PJM Interconnection, L.L.C.
Docket No. ER23-1240-000

Issued: April 21, 2023

Re: *PJM Interconnection, L.L.C., Docket No. ER23-1240 -000*
Amendment to ISA, SA No. 5680; Queue No. AC1-120/AC1-121 (amend)

CUSTOMER FACILITY LOCATION/SITE PLAN

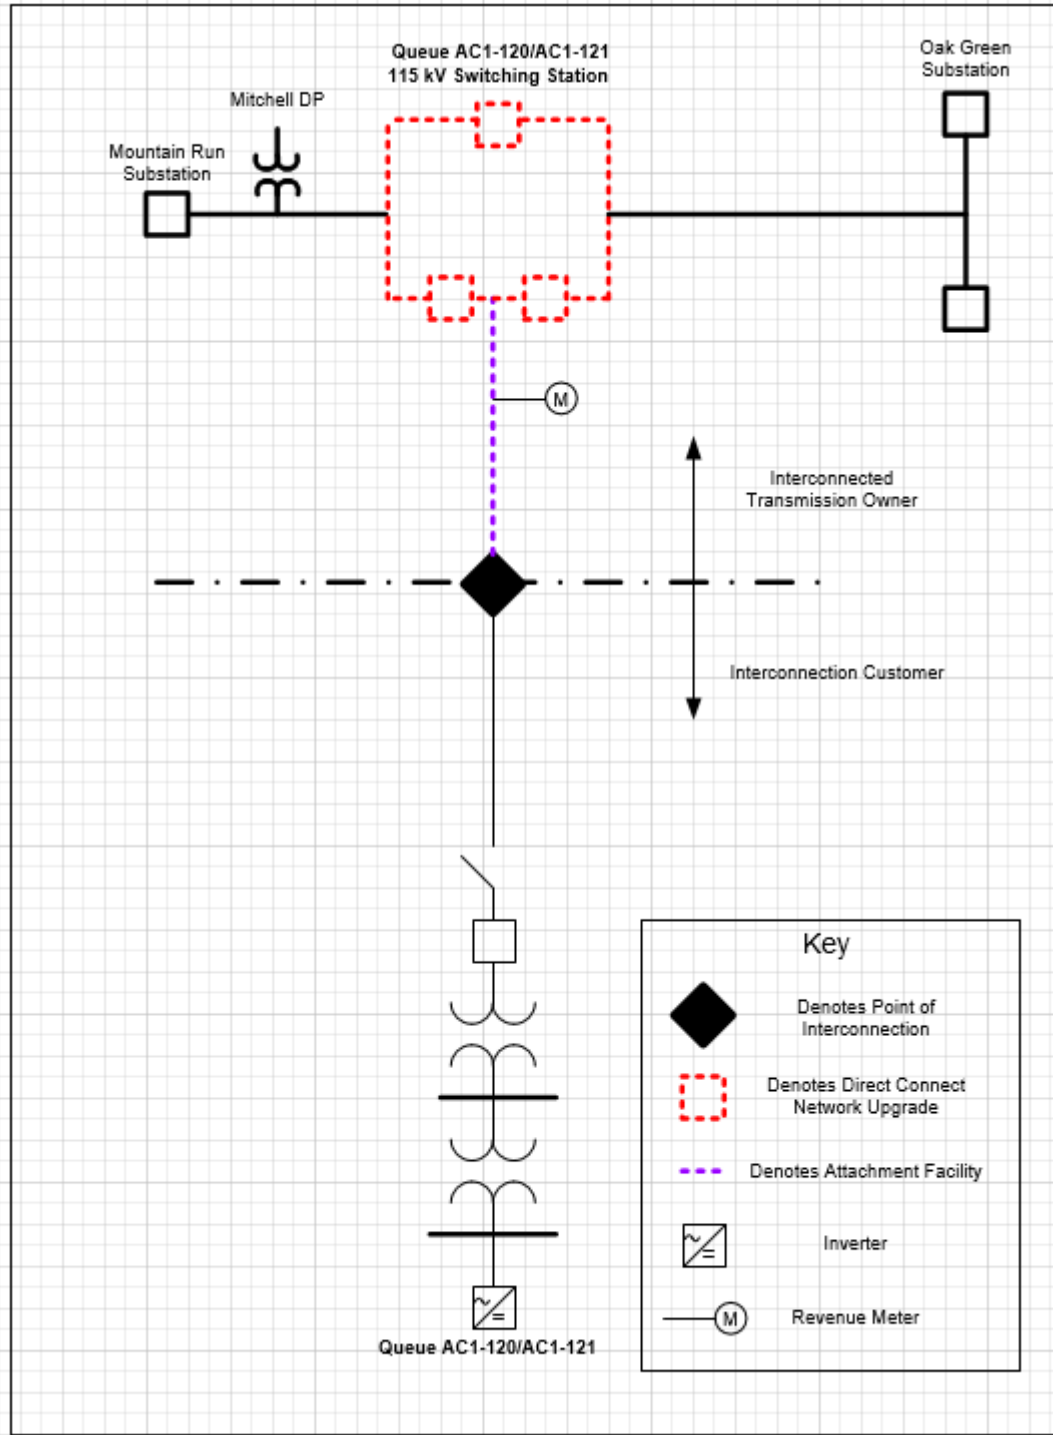
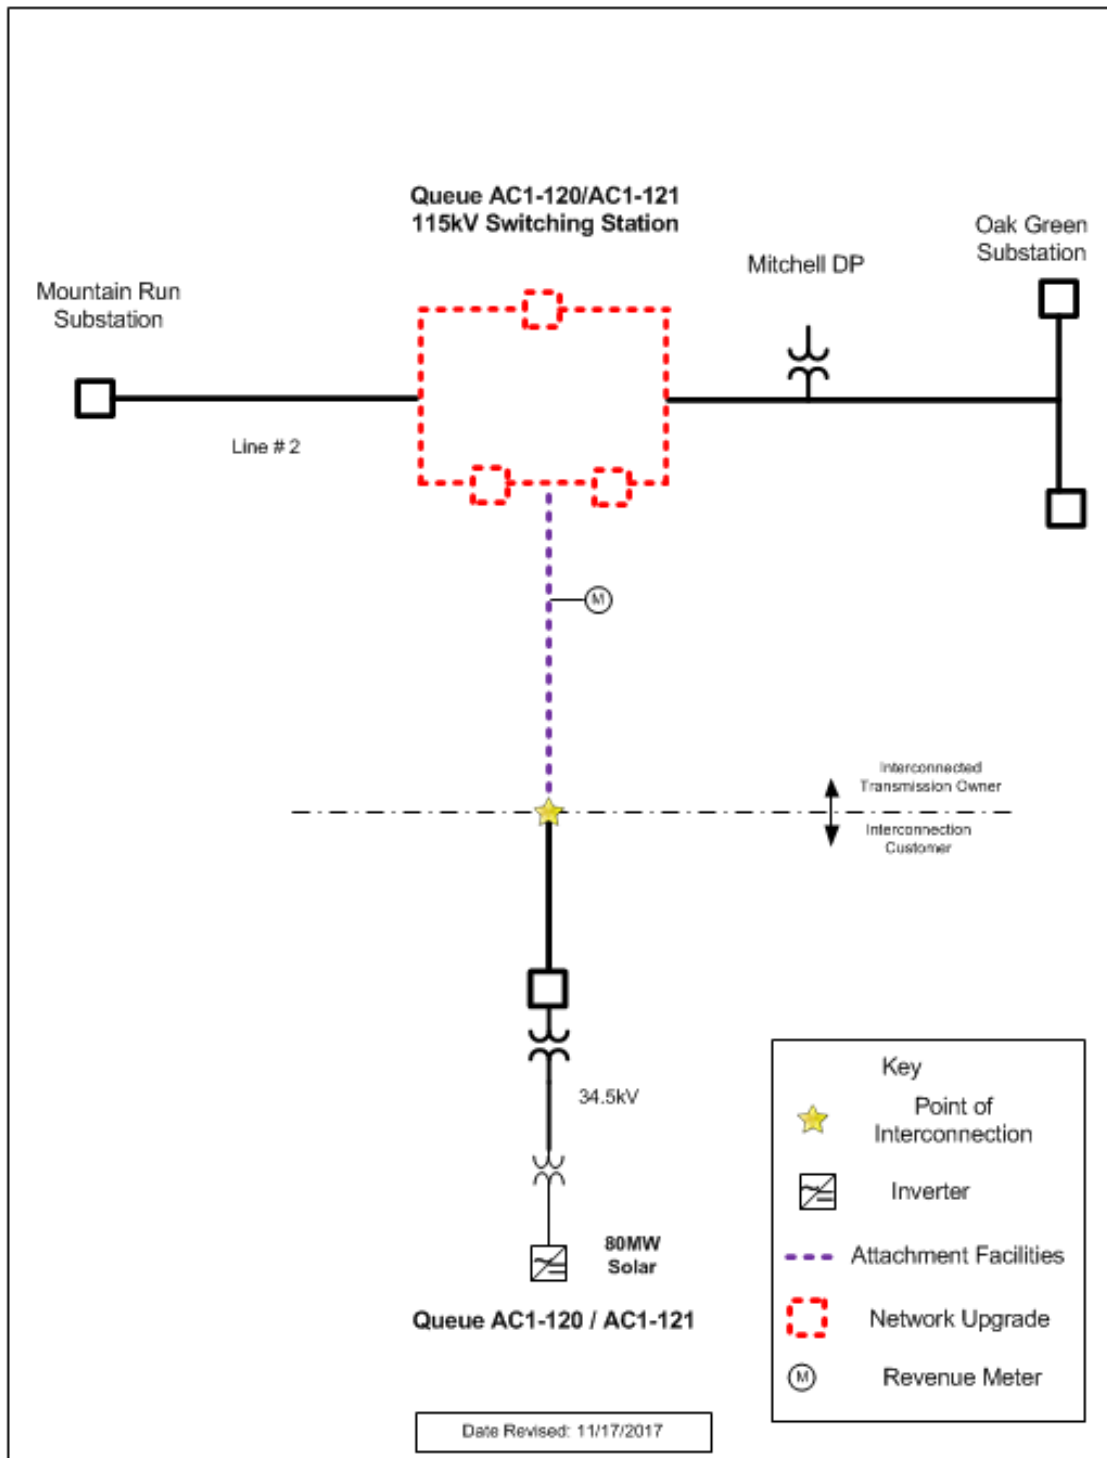
~~GPS: 38.369281, -77.968491~~

GPS/Project Coordinate Reference: 38°20'21.19"N, 77°56'53.60"W
